THREE KINGS RENEWAL, ADDENDUM TO STORMWATER MANAGEMENT PLAN, OPTION 15H2

This letter forms an addendum to the Three Kings Renewal Stormwater Management Plan produced by Pattle Delamore Partners in September 2014. The addendum addresses questions identified by Auckland Council in their correspondence to Fletcher Residential Ltd of 26th August 2014 and 24th September 2014. The points addressed by PDP are items 48, 51, 54 relating to correspondence on 26th August and items 5.4, 8.1, 8.2, 8.5, 8.6, 8.13 relating to correspondence on 24th September 2014.

Figure 1: Soakage Trench

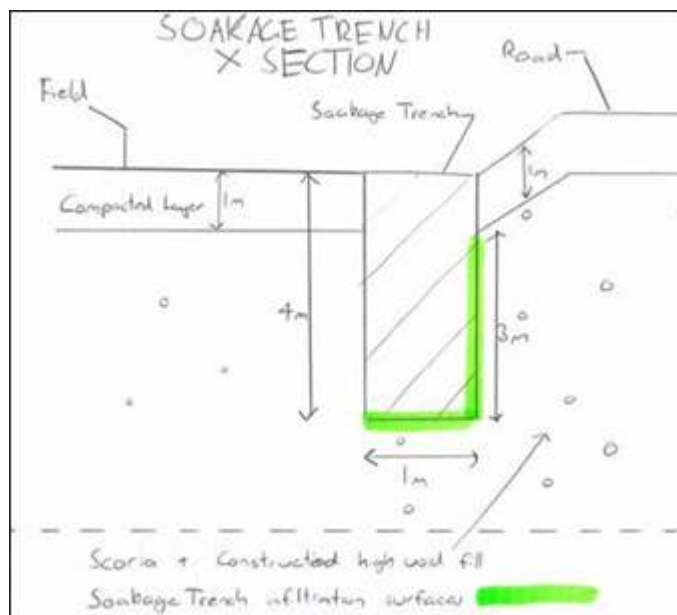
Please provide further information on the expected flooding frequency/duration of the proposed sportsfields and the likely impact on use of the fields (i.e. field closures, additional maintenance and field repair following storm events).

This is an assessment of the time taken to fully discharge stormwater from the parks to ground at the proposed Three Kings Renewal development for a range of stormwater events and soakage rates. This requires a conceptual design of the soakage method to the local and wider ground conditions.

Ultimate stormwater disposal from the parks has been assumed to occur via soakage trenches excavated into the scoria at the south side of the field areas for both options 15H1 and 15H2 (as shown in Figure 1 below). For this conceptual design, five soakage trenches of length 50m each have been used (for a total of 250m of actual trench). Infiltration has been assumed to occur only through one wall towards the perimeter of the site and through the base of the soakage trenches (green on Figure 1).
